## LIST OF AFFECTED PAGES

<u>Page</u>	<u>Section</u>	<u>Description of Change(s)</u>
xx(a)	INDEX	Add Figure 3.4.6.1.c to the List Of Figures
xxiv	INDEX	Delete reference to Table B3/4.4.6-1
1-10	DEFINITIONS	Add note referring to Special Test Exception 3/4.10.7
3/4 4-18	P/T Limits	Added reference to new Figure 3.4.6.1C in two places
3/4 4-21a	P/T Limits	Added new Figure 3.4.6.1C to new page 3/4 4-21a
3/4 10-7	Special Test Exceptions	Added Special Test Exception 3/4.10.7, Inservice Leak And Hydrostatic Testing Operation
B 3/4 4-4	Bases, P/T Limits	Deleted reference to Table B 3/4.4.6.1. Added reference to Figure 3.4.6.1C in two places.
B 3/4 4-5	Bases, P/T Limits	Added reference to Figure 3.4.6.1C.
B 3/4 4-6	Bases, P/T Limits	Deleted Table B 3/4.4.6-1
B 3/4 10-1	Bases, Special Test Exceptions	Added a Bases section, 3/4.10.7, for the new Technical Specification 3/4.10.7

### 3/4.4.6 PRESSURE/TEMPERATURE LIMITS

# WNP-2 PRESSURE/TEMPERATURE LIMITS FOR 8 EFY TESTING AND NONNUCLEAR HEATING CURVES A' & B'

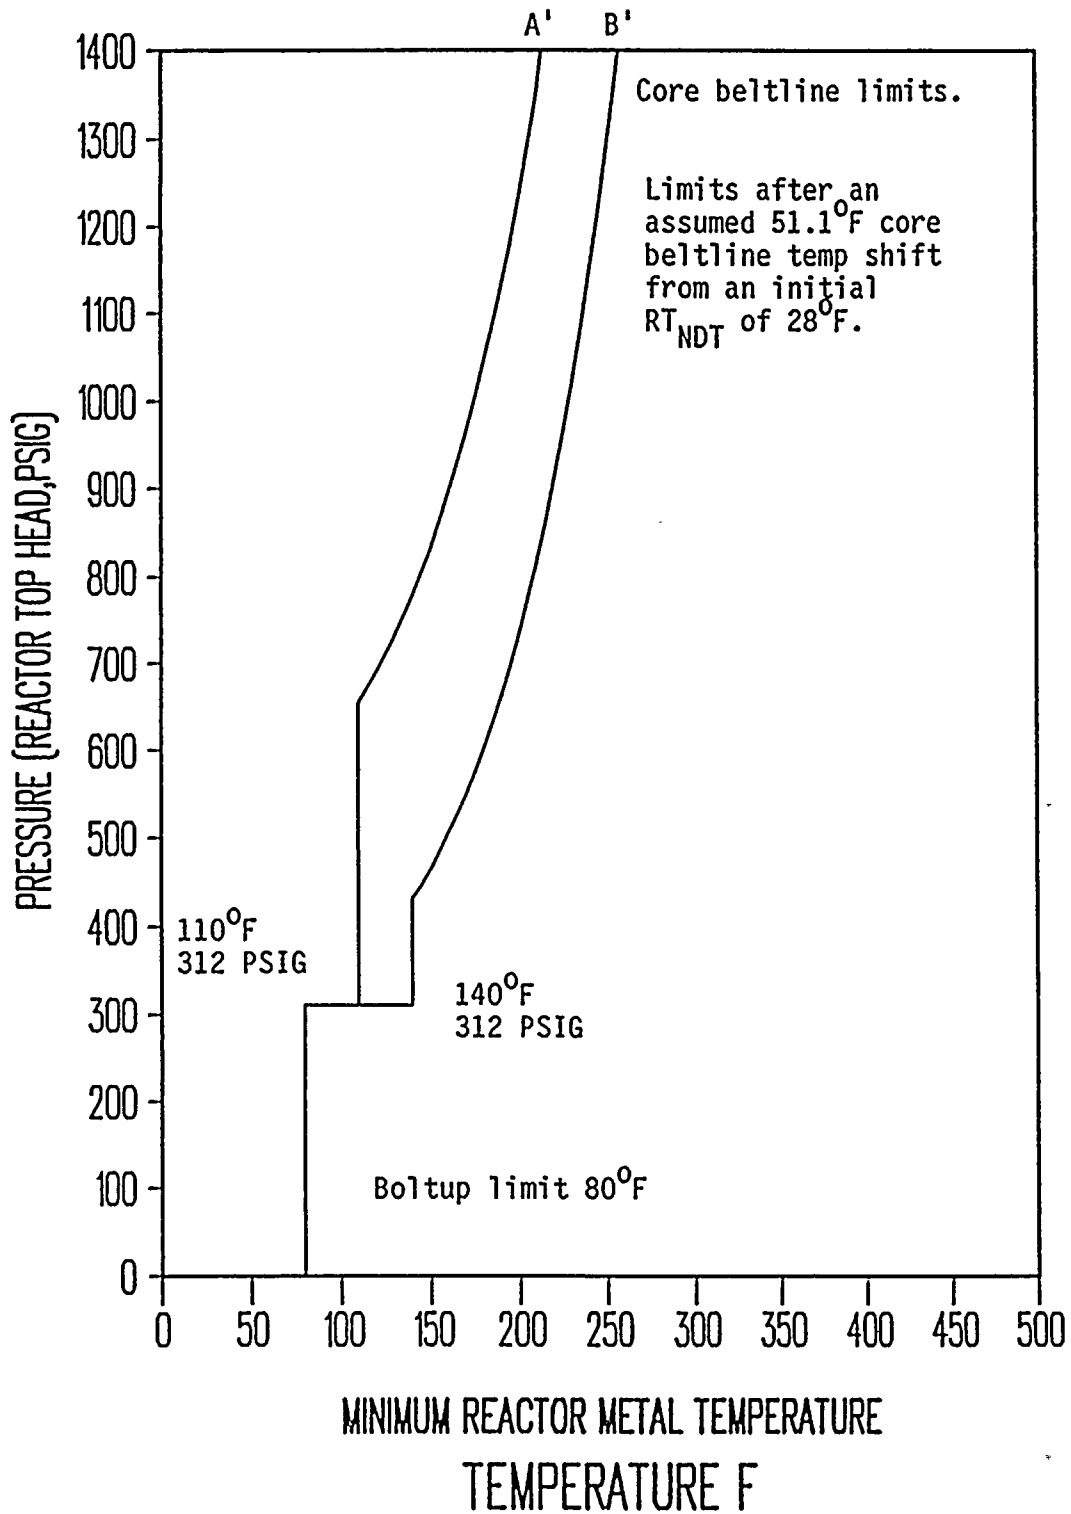
\* Figure 3.4.1.6.C A' and B' curves are effective for less than or equal to 8 EFPY of operation

Add:

Figure

3.4.6.1C
